| A    | Solar panel re-positioning | 08 | 20/07/2026 |

Project Title  
**Proposed Commercial units & Flats**  
New Road, Skewen, Neath, SA10 6EP

Drawing Title  
**Proposed Eleavtions**

| Job No.<br><b>1367</b>  | Drawing No.<br><b>04</b> | Revision<br><b>A</b> |

Front Elevation  
1:100

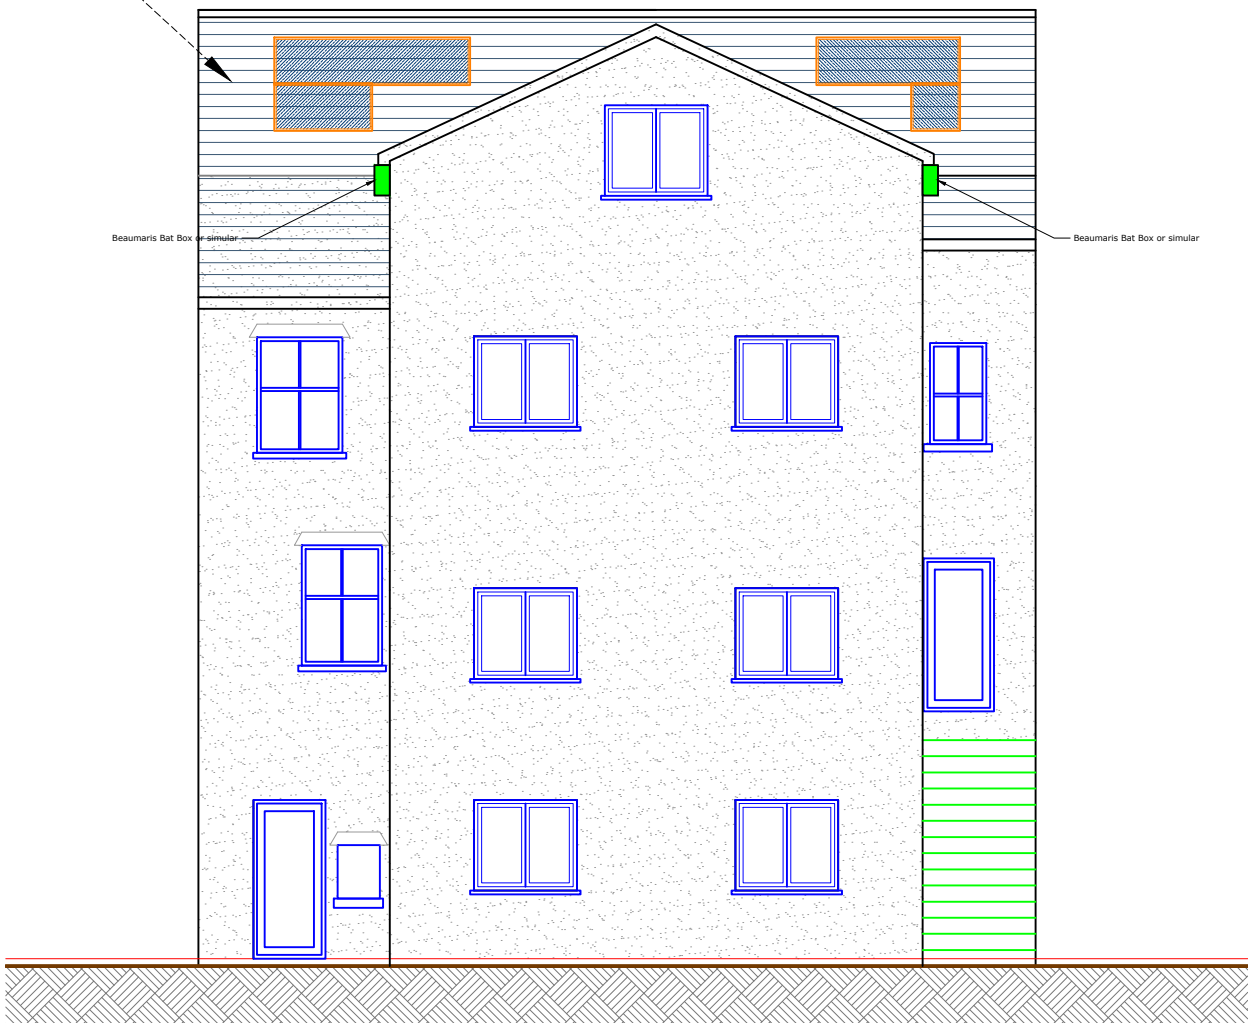
Maintain a 1.0 m clearance from the roof edge. Solar panels must not protrude more than 20 mm above the original roof surface.
